Illinois Tollway M-ITS Base Sheet Revisions

| Section M Base Sheet Drawings | | |
| Drawing | Modification Summary | Effective: 2021-03-01 |

M-ITS-1500

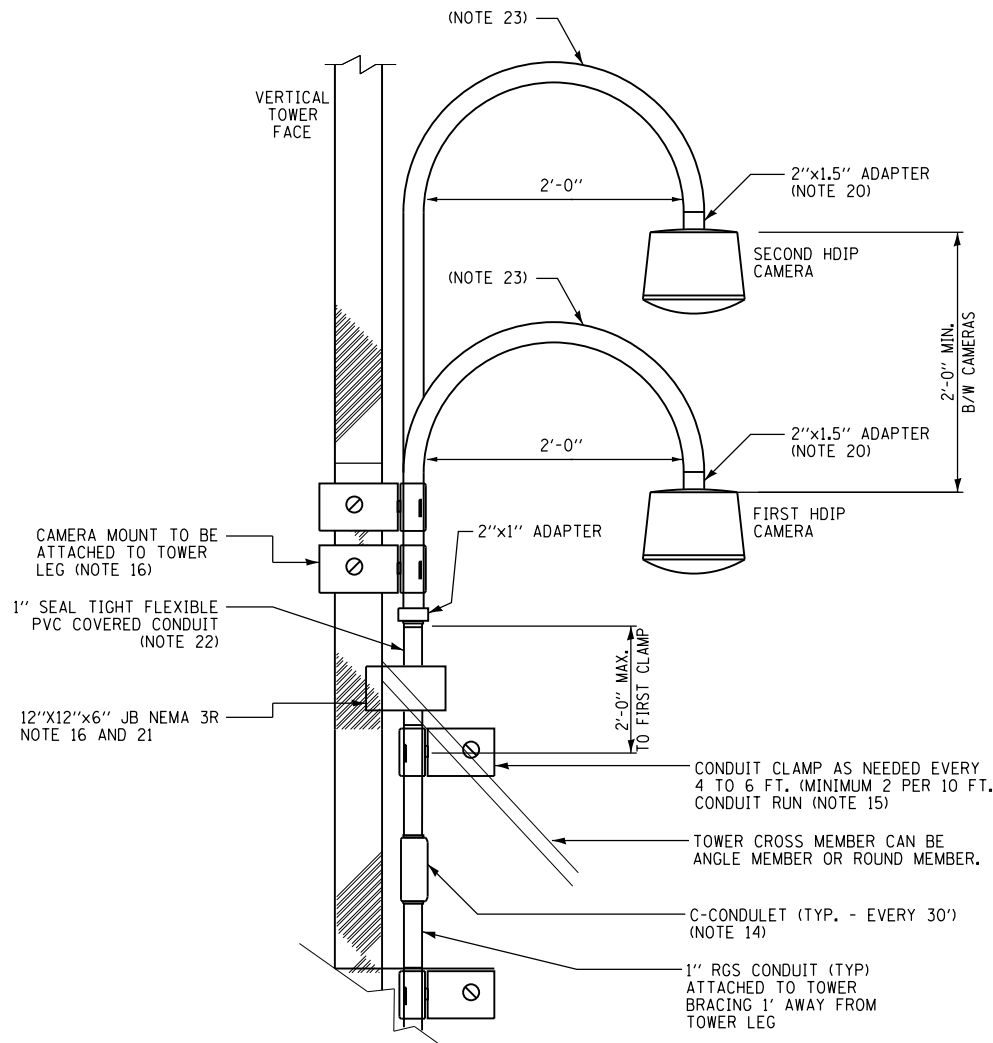
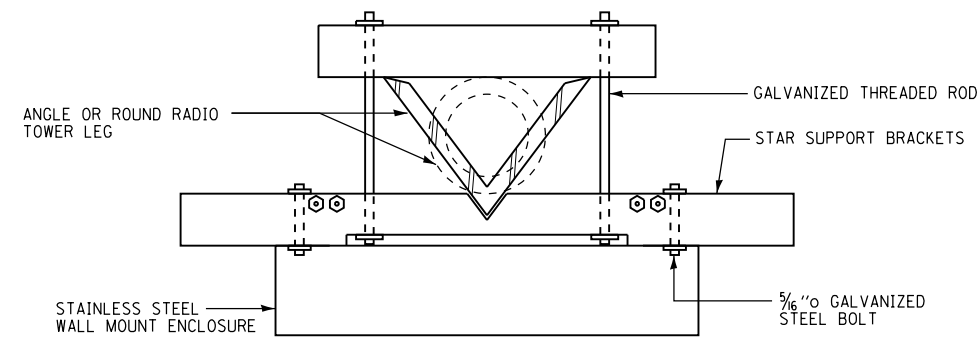
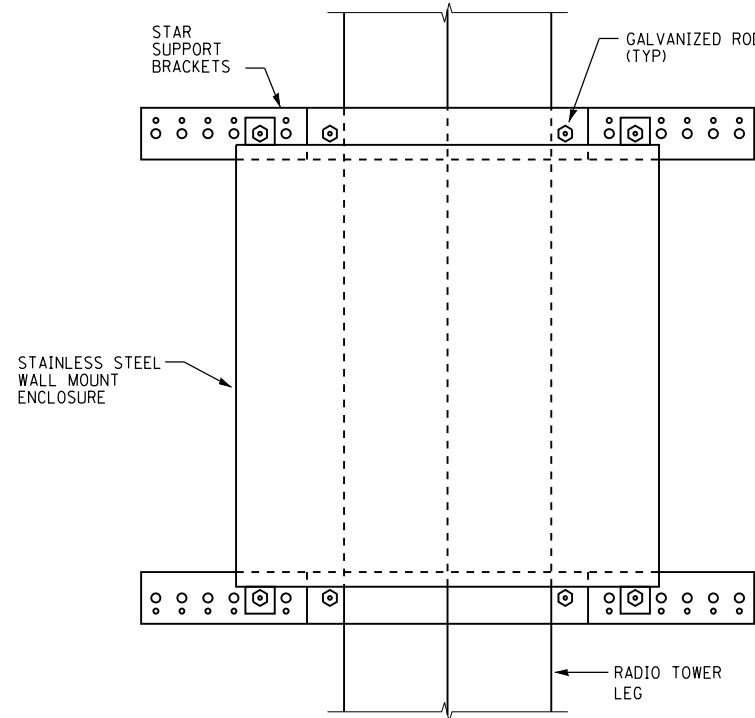
| Section M Base Sheet Drawings | |
|--|---|
| | . Added note to Designer: The 2 CCTV shall be placed on the leg facing the roadway with a clear field of view . Added Note 23: The CCTV cameras shall be mounted on the same tower leg with an Axis T92B62 mounting arm with T94A01D pendant kit, or equivalent as approved by the engineer. There will be 24in vertical spacing between the cameras |

- TRANSITION ETHERNET AND POWER CABLES.
- ALL CONDUITS MUST CONNECT TO BOTTOM OF 12"x12"x6" NEMA 4X ENCLOSURE.
- THE CCTV CAMERAS SHALL BE MOUNTED ON THE SAME TOWER LEG WITH AN AXIS T92B62 MOUNTING ARM WITH T94A01D PENDANT KIT, OR EQUIVALENT AS APPROVED BY THE ENGINEER. THERE WILL BE 24" VERTICAL SPACING BETWEEN THE CAMERAS.

THE 2 CCTV'S SHALL BE PLACED ON THE LEG FACING THE ROADWAY WITH A CLEAR FIELD OF VIEW.
